August 4, 1994

RE: Tecumseh Products Company
Grafton, Wisconsin, Plant

Representatives of the Wisconsin Department of Natural Resources (WDNR), Tecumseh Products Company, and RMT, Inc., met on July 20, 1994, at your office to discuss the comments contained in your letter dated April 26, 1994, to Tecumseh Products regarding a series of underground storage tank-related documents that E&K Hazardous Waste Services and Fox Environmental Services had submitted. This letter has been prepared on behalf of Tecumseh Products to document that meeting and to respond to the WDNR's concerns raised in your letter.

LOCATIONS OF THE FOUR FORMER GASOLINE UNDERGROUND STORAGE TANKS

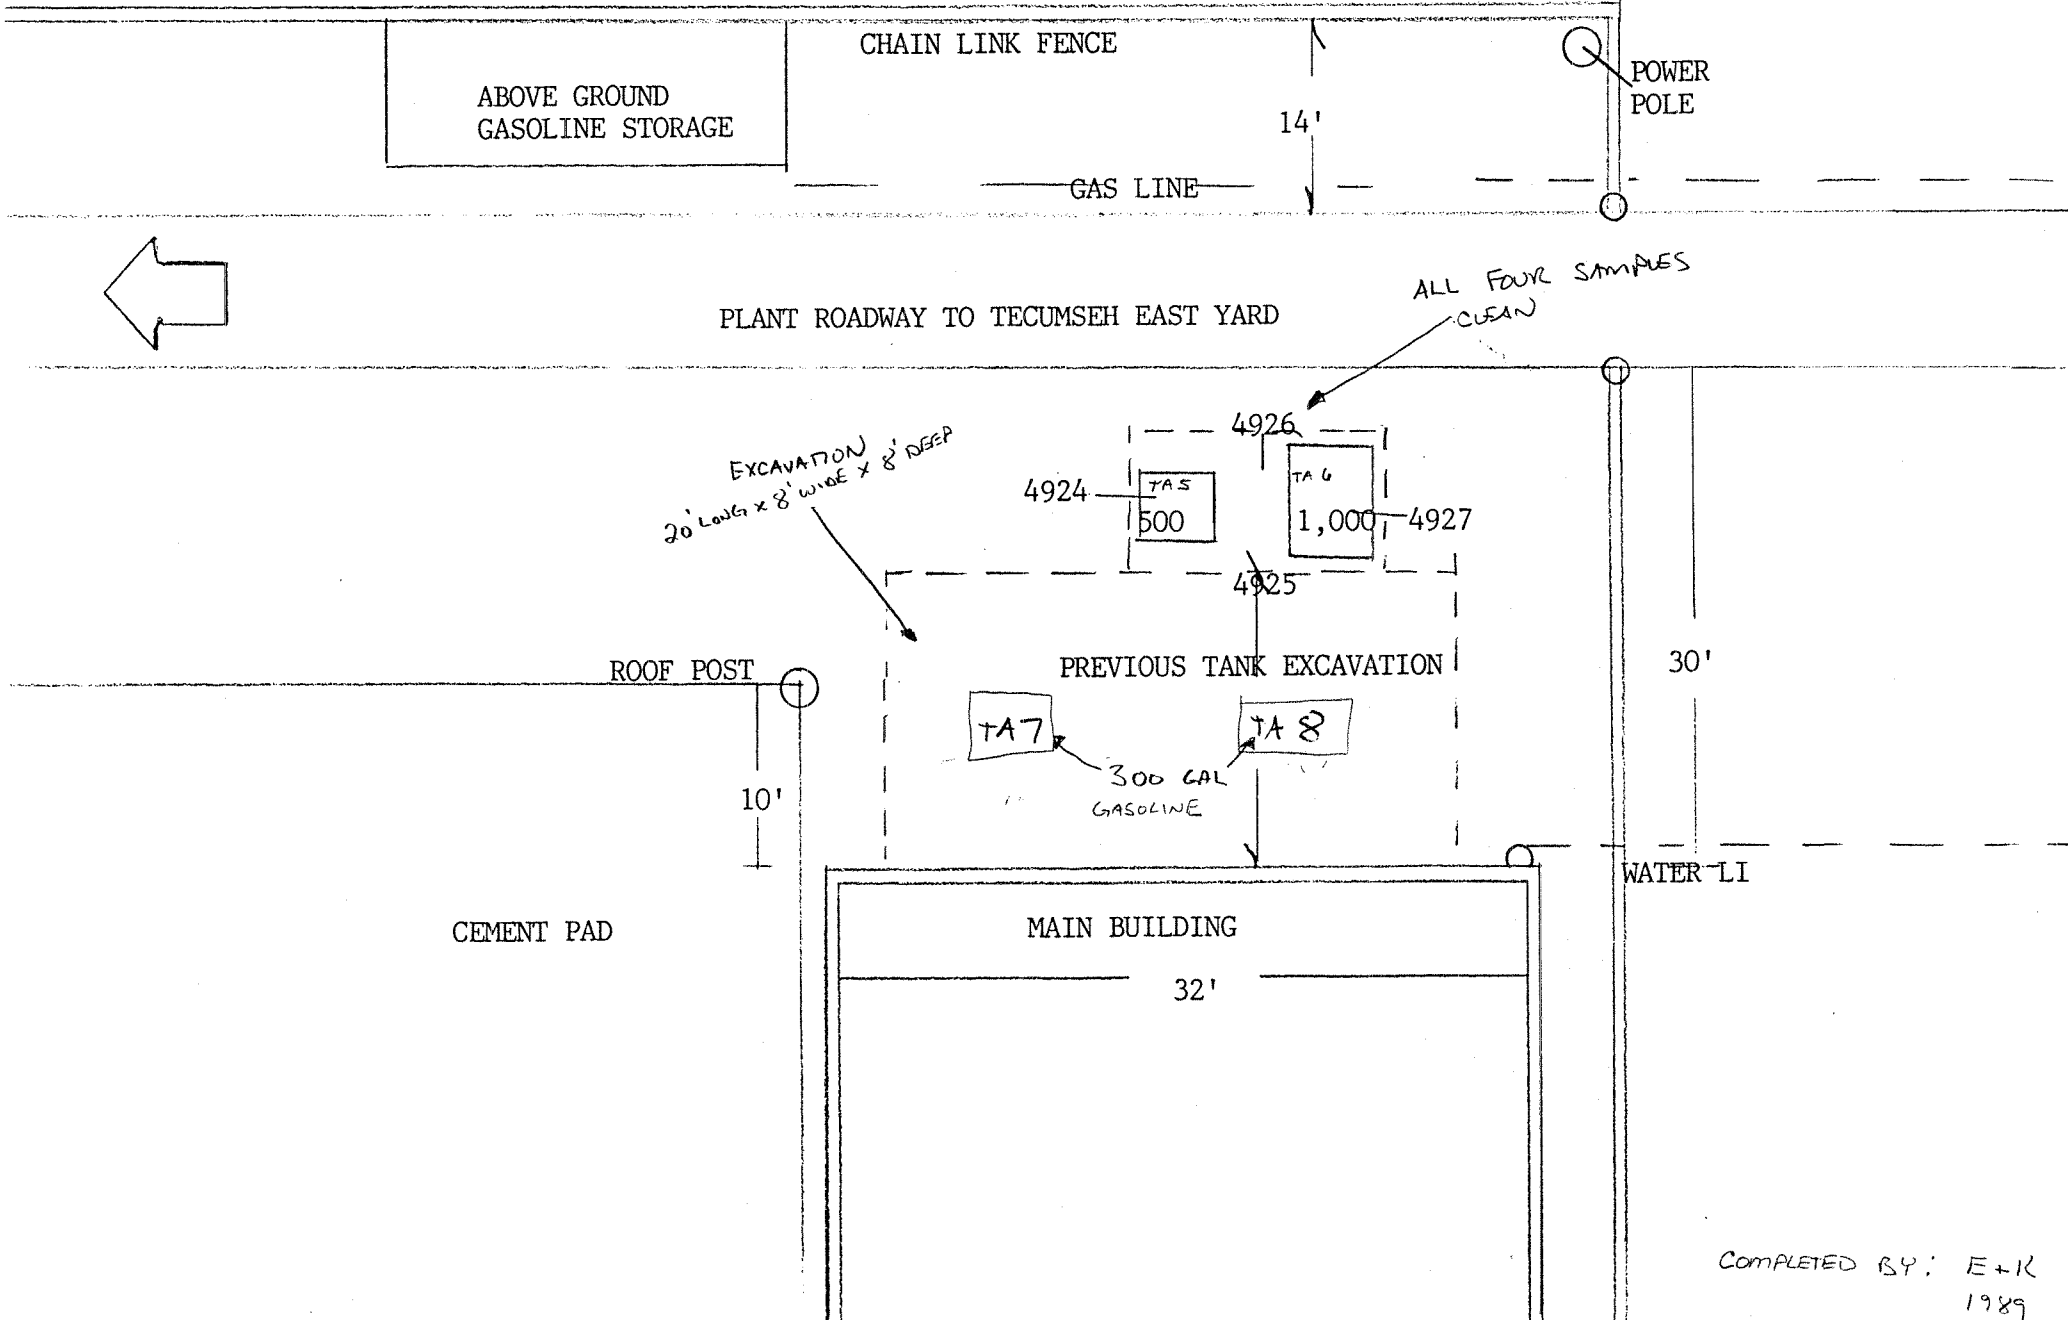
Comment 6: Based on the letter report by E&K regarding the gasoline USTs in the southeast part of the plant, dated 12/21/88, soil samples were apparently taken from the over-excavated area on 12/16/88. The results of these samples were not submitted to the

WDNR. Contamination was noted when the first two tanks were removed, but no documentation of the investigation or remediation of that area was submitted. This information should be submitted for review. If you will be seeking PECFA reimbursement for the excavation done in this area, you must provide adequate documentation for both the presence of contamination and its appropriate remediation.

Response: Four gasoline USTs were removed from the southeast side of the facility (shown on Attachment 1) during 1988 and 1989. They were as follows:

TA8 was removed first. A release from this tank was confirmed and reported to the WDNR. Over-excavation of the contaminated soil to the north was halted though, due to the presence of TA7. TA7 was determined to be nonessential to facility operations and was removed to further facilitate over-excavation of contaminated soil. The TA7 excavation showed signs of gasoline contamination, but the source may have been TA8 (E&K December 6, 1988, letter). The combined TA7/TA8 tank pits were over-excavated to the extent practicable. The total excavated area was 20 feet long by 8 feet deep by 8 feet wide. Sixty-five cubic yards of contaminated soil were removed and hauled to the Omega Landfill.

Four samples (1 from each wall of the excavation) were collected from the combined TA7/TA8 excavation on December 16, 1988; however, the analytical results for these samples cannot be located in Tecumseh Products' files. Tecumseh Products has requested the analytical reports from E&K.

TA5 and TA6, which were nested together, were removed approximately 10 months after TA7 and TA8. Four samples from the TA5/TA6 excavation were collected. The results were all less than 4 ppm TPH. Sample 4925 was located on the western wall of the combined TA5/TA6 excavation. Tecumseh Products is waiting for a response from Superior Environmental (formerly E&K) and/or CBC. The results will be forwarded to Pam Mylotta upon receipt by Tecumseh Products.
